Source: Ericsson
Title: DPCH synchronisation, revised
Document for: Decision

5 Text proposal for 25.211 V2.2.1

6 Text proposal for 25.214 V1.1.1

Figure 2: Synchronization Establishment Flow of Dedicated Channels.

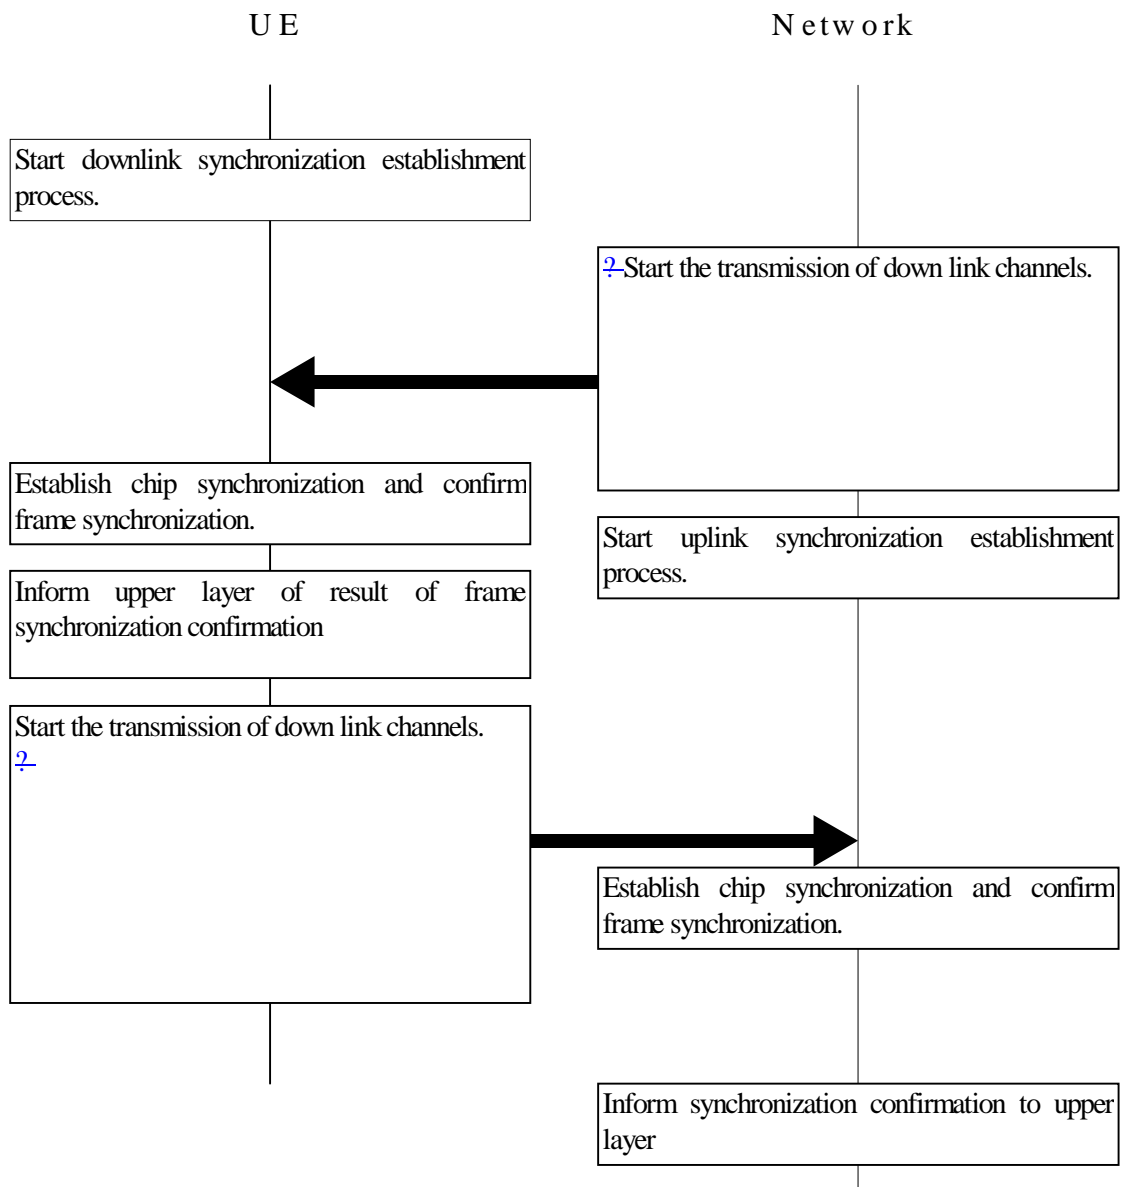
The ~~outline of~~ synchronization establishment procedures of the dedicated physical channel is described below. The ~~detailed~~ synchronization establishment process flow is shown in Figure 2.

- UTRANThe network starts the transmission of downlink DPCCH/DPDCH channels. The TPC commands transmitted by the network follows a predetermined pattern, *< Editor's note: What pattern? >*. The DPDCH is transmitted only when there is data to be transmitted to the UE.

- b) The UE establishes downlink chip synchronization and frame synchronization based on the ~~Primary CPICH~~ Primary CPICH synchronization timing and ~~timing offset information~~ the frame offset group, slot offset group notified from ~~UTRAN~~ the network. ~~The frame synchronization can~~ be confirmed using the Frame Synchronization Word. Successful frame synchronization is confirmed and reported to the higher layers ~~The success of the frame synchronization confirmation is determined when the successive- S_R successive frames have been confirmed to be frame synchronized~~ is confirmed. Otherwise, the frame synchronization confirmation failure is determined. Then this synchronization status information is reported to the higher ~~upper~~ layers.

- c) The UE starts the transmission of ~~the uplink DPCCH/DPDCHs channels at the a frame timing delayed by the slot offset~~ exactly T_0 chips after from the frame timing of the received downlink channel DPCCH/DPDCH. The DPDCH is transmitted only when there is data to be transmitted ~~to the network.~~ The UE immediately starts closed loop power control as described in sections 5.1.2 and 5.2.3, i.e. The the transmission power of the uplink DPCCH/DPDCH ~~uplink channels follows the TPC commands transmitted by the network generated by UTRAN, and the UE performs SIR estimation to generate TPC commands transmitted to UTRAN, by the UE are based on downlink SIR measurements.~~

- d) ~~UTRAN~~ The network establishes uplink channel chip synchronization and frame synchronization, ~~based on the frame offset group and slot offset group.~~ Frame synchronization can ~~be confirmed using the Frame Synchronization Word. Successful frame synchronization is confirmed and reported to the higher layers when S_R successive frames have been confirmed to be frame synchronized. Otherwise, frame synchronization failure is reported to the higher layers.~~ The success of the frame synchronization confirmation is determined when the successive S_R frame synchronization is confirmed. Otherwise, the frame synchronization confirmation failure is determined. Then this synchronisation status information is reported to the upper layer. The transmission power of the downlink channels follow the TPC commands transmitted by the UE.

Figure 3: Synchronization Establishment Flow upon Intra/Inter-cell Diversity soft Handover

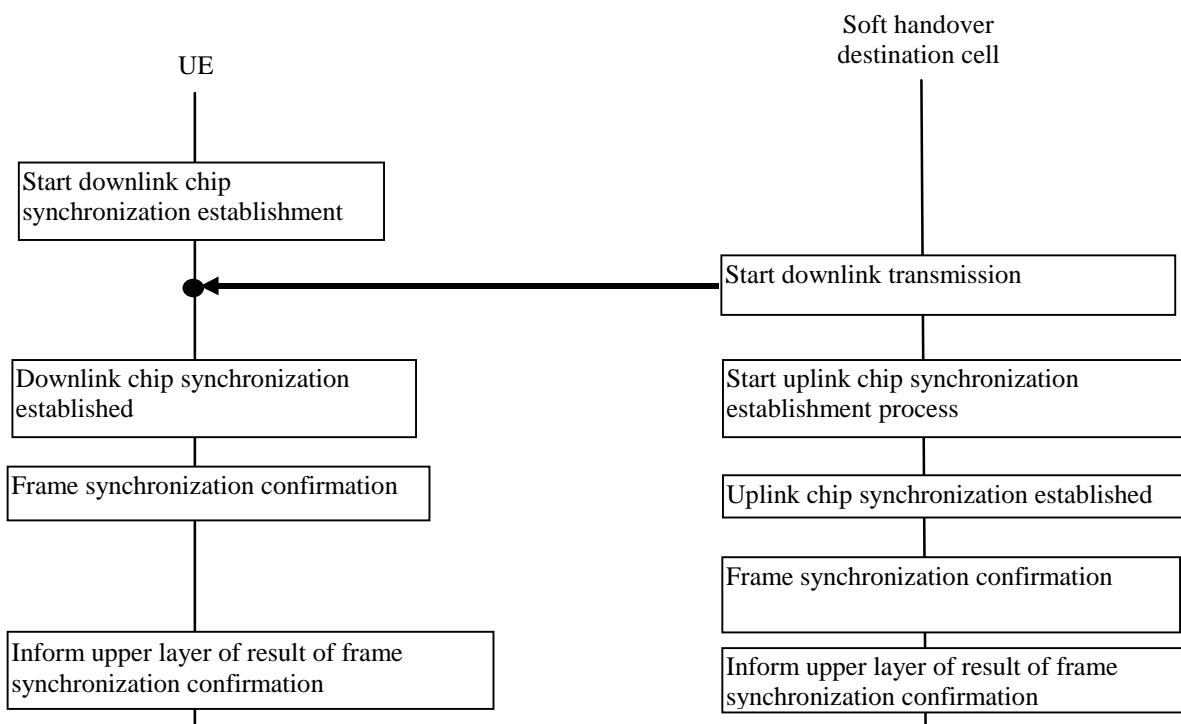
< Editor's note: The actual procedure below is based on the material in Volume 3 section 3.2.6.6.1. Material not relevant for L1 has been removed. The terminology should be updated in accordance with the rest of the specification. The figure should also be updated. This will be done in the next version of this document. The criteria for synchronisation confirmation should be considered informative, and should be moved to an informative annex >

At the start of diversity-soft handover, the uplink dedicated physical channel transmitted by the UE, and the downlink dedicated physical channel transmitted by the softdiversity handover source node-Bcell continues transmitting as usual. will have their radio frame number and scrambling code phase counted up continuously as usual, and they will not change at all.

The synchronisation establishment flow upon intra/inter-cell diversity-soft handover is described in Figure 3.

- a) The UE starts the chip synchronisation establishment process of downlink channels from the handover destination. The uplink channels being transmitted shall continue transmission as before without any operations performed.

- b) ~~The network UTRAN starts the transmission of the downlink dedicated physical channels DPCCH/DPDCH at a frame timing such that the frame timing received at the UE will be within $T_0 \pm 128$ chips prior to the frame timing of the uplink DPCCH/DPDCH at the UE. UTRAN then and starts the synchronization establishment process of the uplink dedicated physical channel DPCCH/DPDCH transmitted by the UE. -Frame synchronization could-can be confirmed using the Frame Synchronization Word. Successful frame synchronization is confirmed and reported to the higher layers when S_R successive frames have been confirmed to be frame synchronized. Otherwise, frame synchronization failure is reported to the higher layers. The success of the frame synchronization confirmation is determined when the successive S_R frame synchronization is confirmed. Otherwise, the frame synchronization confirmation failure is determined. Then this synchronization status information is reported to the upper layer.~~

- c) Based on the handover destination ~~Primary CCPCH/CPICH~~ reception timing, the UE establishes chip synchronisation of downlink channels from handover destination ~~node B~~ cell. Frame synchronization could-can be confirmed using the Frame Synchronization Word. Successful frame synchronization is confirmed and reported to the higher layers when S_R successive frames have been confirmed to be frame synchronized. Otherwise, frame synchronization failure is reported to the higher layers. The success of the frame synchronization confirmation is determined when the successive S_R frame synchronization is confirmed. Otherwise, the frame synchronization confirmation failure is determined. Then this synchronization status information is reported to the upper layer.
